RE: GRADING & DRAINAGE PLAN FOR VALENCIA APARTMENTS (K-18/D080)
ENGINEERS STAMP DATED JUNE 8, 2000 SUBMITTED FOR BUILDING
PERMIT & GRADING PERMIT APPROVAL

RE: GRADING & DRAINAGE PLAN FOR VALENCIA APARTMENTS (K-18/D080)
ENGINEER'S STAMP DATED AUGUST 10, 2000, SUBMITTED FOR
BUILDING PERMIT & GRADING PERMIT APPROVALS

RE: Valencia Apartments (K18-D080) - Drainage Supplemental

RE: Valencia Apartments (K18-D080) - Drainage Resubmittal

200003 JOB #		8208 JOTTISON ME ALBUQUERQUE, NEW MEXICO 87113 TERRA WEST, LLC	
200302LWS SHEET #		BASIN EXHIBIT DATE: 08-08-08 BY: JON	
200003 JOB #		VALENCIA APARTMENTS

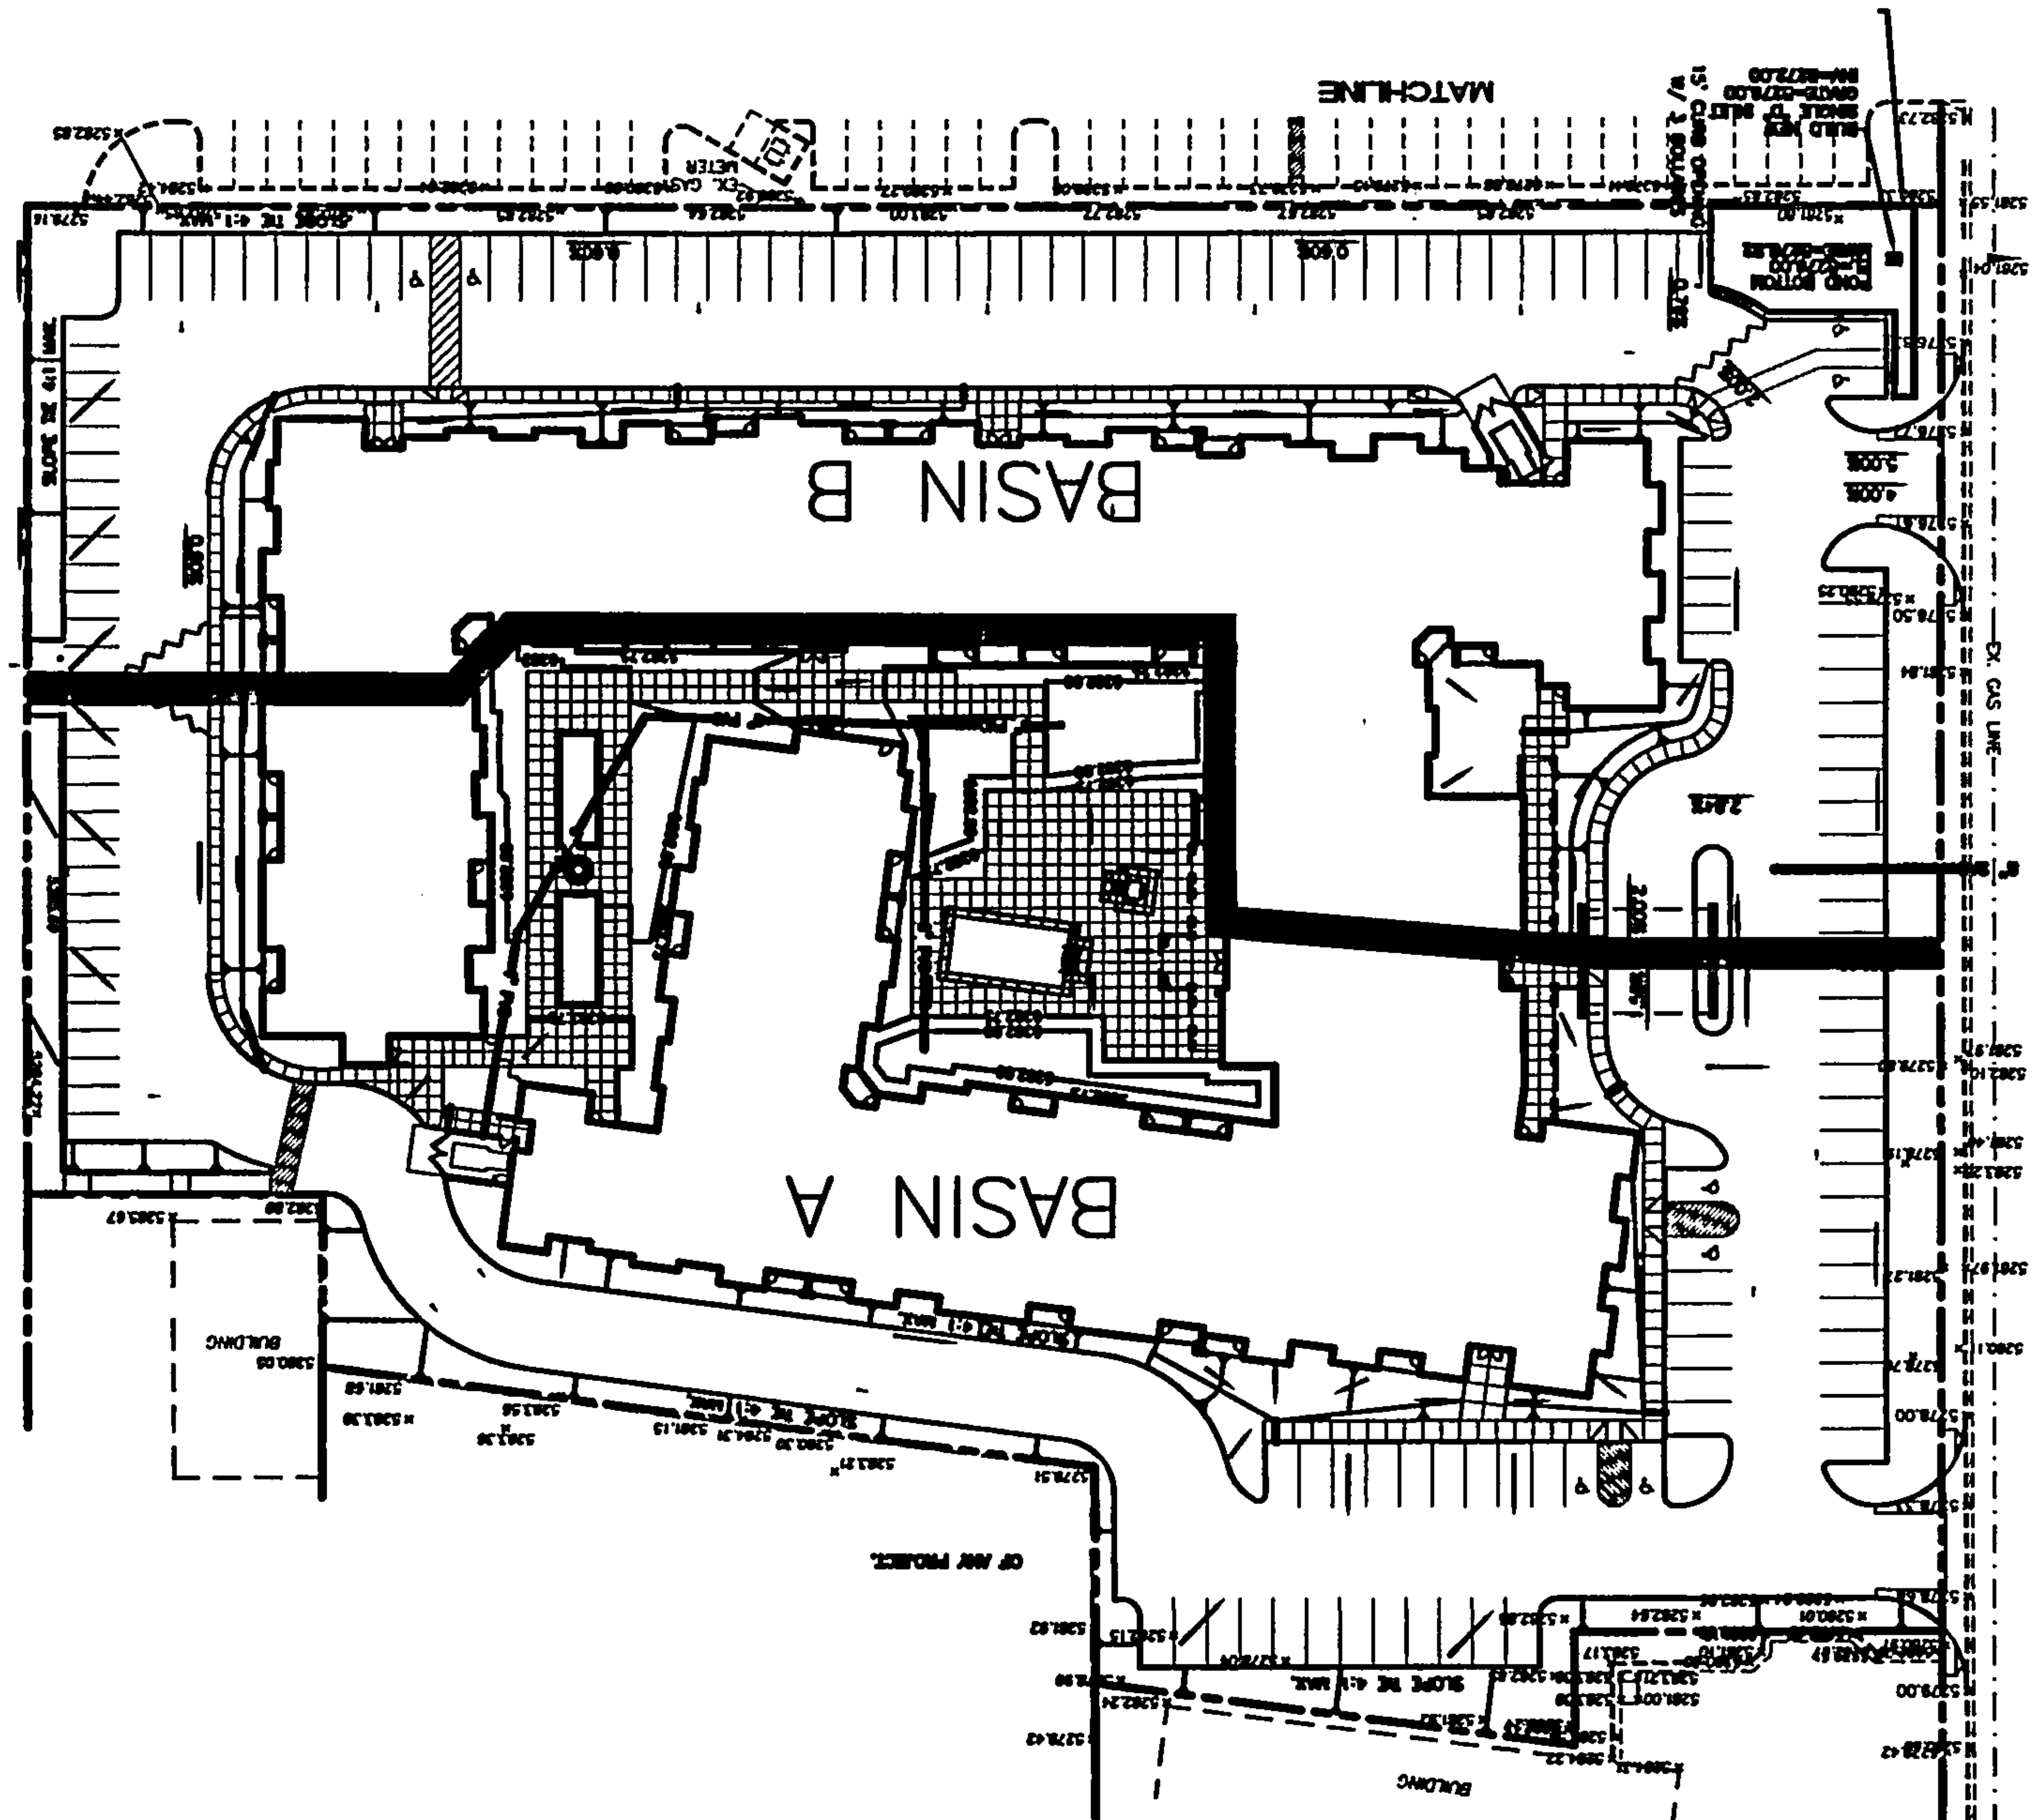
While it is true that the site lies in a Zone X flood plain, the run-off from this site contributes to a Zone AO (Depth 1) flood zone immediately downstream. Increasing the run-off from this site by 8 cfs is not acceptable under these conditions. It is possible that the San Mateo Project mitigated the flooding conditions in this area but that must be established.

Discharging 49 cfs (22,000 gal/min) across a city street is not an acceptable approach to drainage. Is the channel across the street a city structure in a dedicated easement? If the easement exists, one approach would be to extend a line from the inlet at Alvarado east to your site, leaving inlets in Valencia; another approach is to extend the storm drain north from Acoma and Valencia.

Finally, please address the offsite flows from the east in more detail to establish that they can be channeled through the proposed opening on your site.

Please Note: Since this site is partially located within a flood hazard area, please provide additional spot elevations at street level to indicate that the finished floor elevation is at least two foot above street flowline. Also, provide asbuilt elevations for pond #2 and pond #3.

1. The nuisance flows must be contained within either a curb or valley gutter, and not be allowed to sheet flow across Valencia Street.

1. While it is true that the site lies in a Zone X flood plain, the run off from this site contributes to a zone AO (depth 1) flood zone immediately downstream. Increasing the run-off from this site by 8 CFS is not acceptable under these conditions. It is possible that the San Mateo Project mitigated the flooding in this area but that must be established.

2. Discharging 49 CFS across a city street is not an acceptable approach to drainage. Is the channel across the street a city structure in a dedicated easement? If the Easement exists, one approach would be to extend a line from the inlet at Alvarado east to your site, leaving inlets in Valencia, another approach is to extend the storm drain north from Acoma and Valencia.

3. Finally, please address the offsite flow from the east in more detail to establish that they can be channeled through the proposed opening on your site.

We modified the attached grading plan to include the standard 10' valley gutter with and $\frac{3}{4}$ " invert. Due to the location of an existing Sanitary Sewer Manhole, the lid must be replaced with a sealed lid to eliminate infiltration of the flows within the new valley gutter.

2. The minimum size of main line storm drain conduit is 24"
The grading plan was modified by changing the storm drain from an 18" RCP to a 24" RCP.

This is an infill site surrounded on all sides by fully developed property. All the adjacent properties were granted free discharge. The AMDS considered the site fully developed. The site is located within the upper 1/3 of the San Mateo storm drainage basin. In order to calculate the capacity left within the San Mateo system a detailed analysis of over several hundred basins and conduits would be required. This study should not be required of the consultant for a project of this size. The grading plan and drainage report were modified to limit the developed flow to less than the existing peak flow rate.

The grading plan was modified by constructing an 18" storm drain from the intersection of Acoma and Valencia. The flow rate leaving the site via surface flow was reduced to 29.70 CFS. This flow will exit the site through a driveway opening. This opening is 40' wide at the right of way line. The depth and velocity of this flow was determined, using Mannings equation, to be .156 feet deep and 4.76 feet per second. The channel across the street is concrete lined and within a public drainage easement.

The offsite drainage basin map, which is located in appendix B, clearly shows the flow path leading to the location of our rundown. A header curb located along the property line directs the entire flow to the proposed rundown.
